SUB-002978-2024

Crichton Subdivision, Resubdivision of Parts of Lots 7 & 8

- Subdivision approval to create one (1) legal lot of record from one (1) existing metes-and-bounds parcel.

DETAIL SITE PLAN

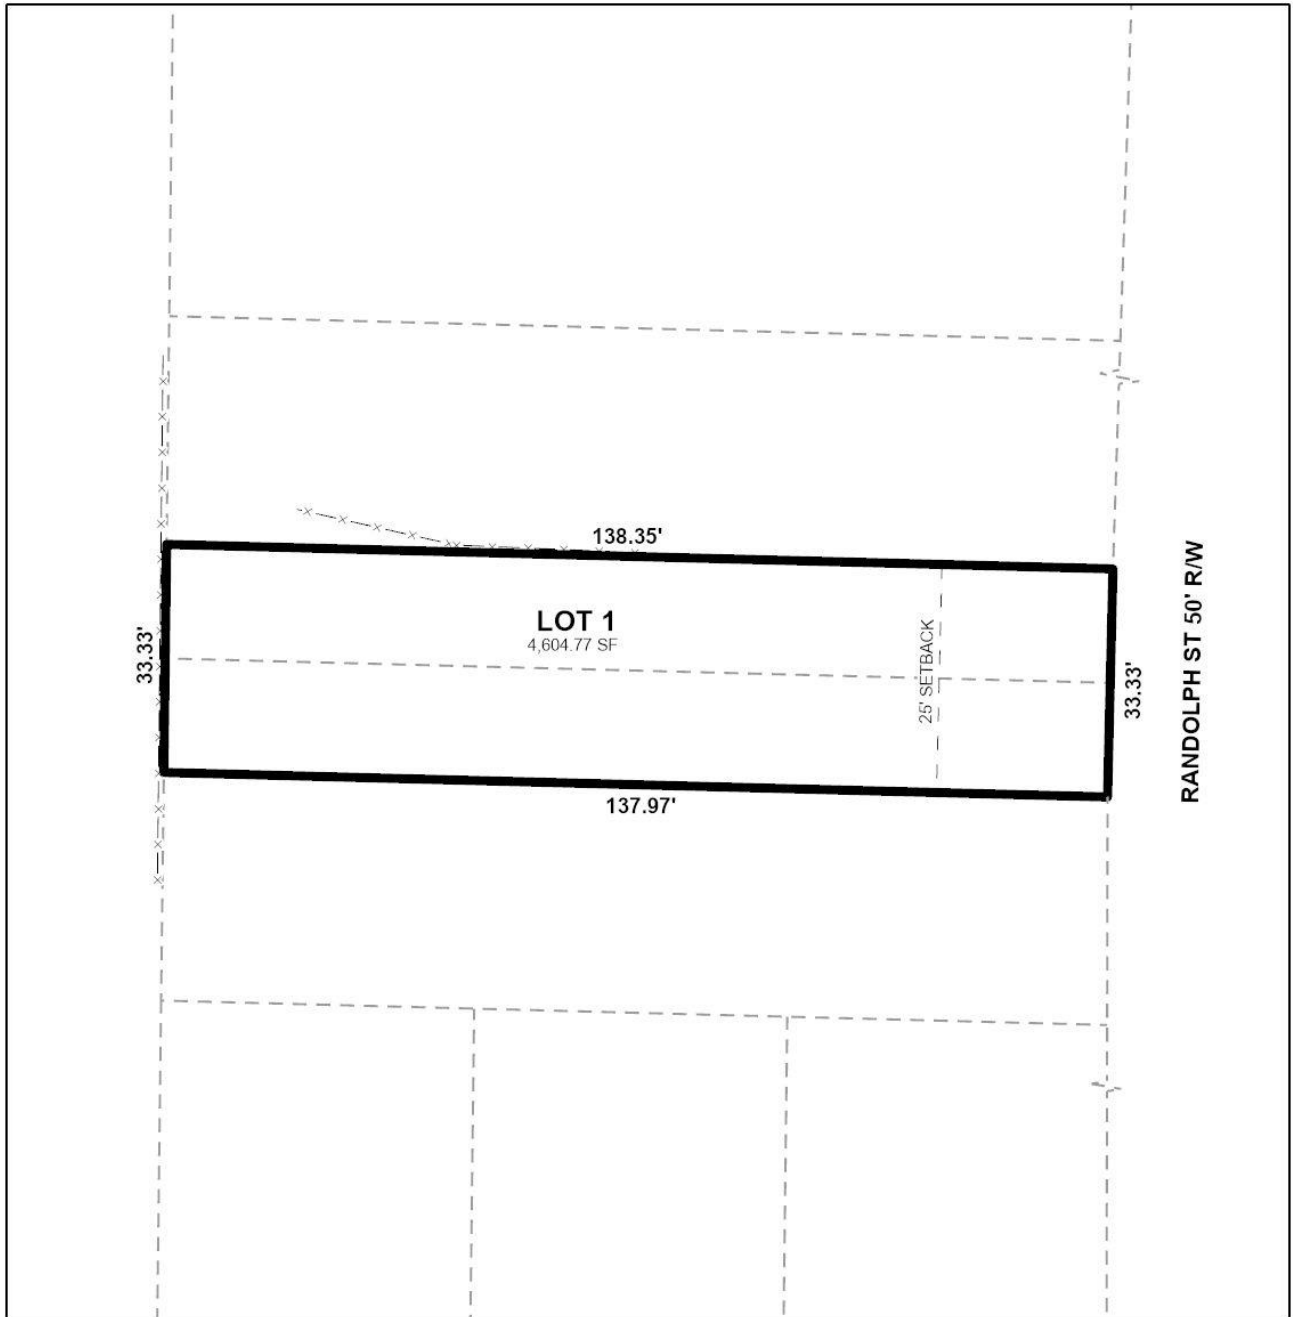
As proposed, the preliminary plat illustrates a sub-standard lot width of 33± feet and a sub-standard lot area of 4,604± square feet. Section 6.C.2(b)(3) of the Subdivision Regulations requires a minimum width of 50 feet for residential lots located within an urban sub-district. Additionally, Section 6.C.2(a)(1) requires a minimum lot area of 6,000 square feet for properties zoned R-1 within an urban sub-district. It should be noted, however, that lots with similarly sub-standard widths and area exist within the immediate vicinity of the subject site and are not uncommon in the area. If the Commission considers approving the request, waivers from Section 6.C.2(b)(3) and Section 6.C.2(a)(1) of the Subdivision Regulations will be necessary.

A 25-foot front yard setback is illustrated along Randolph Street on the preliminary plat; however, the lot is within an urban sub-district and only requires a 5-foot front yard setback. As such, the plat should be revised to illustrate a compliant minimum 5-foot front setback along Randolph Street, if approved.
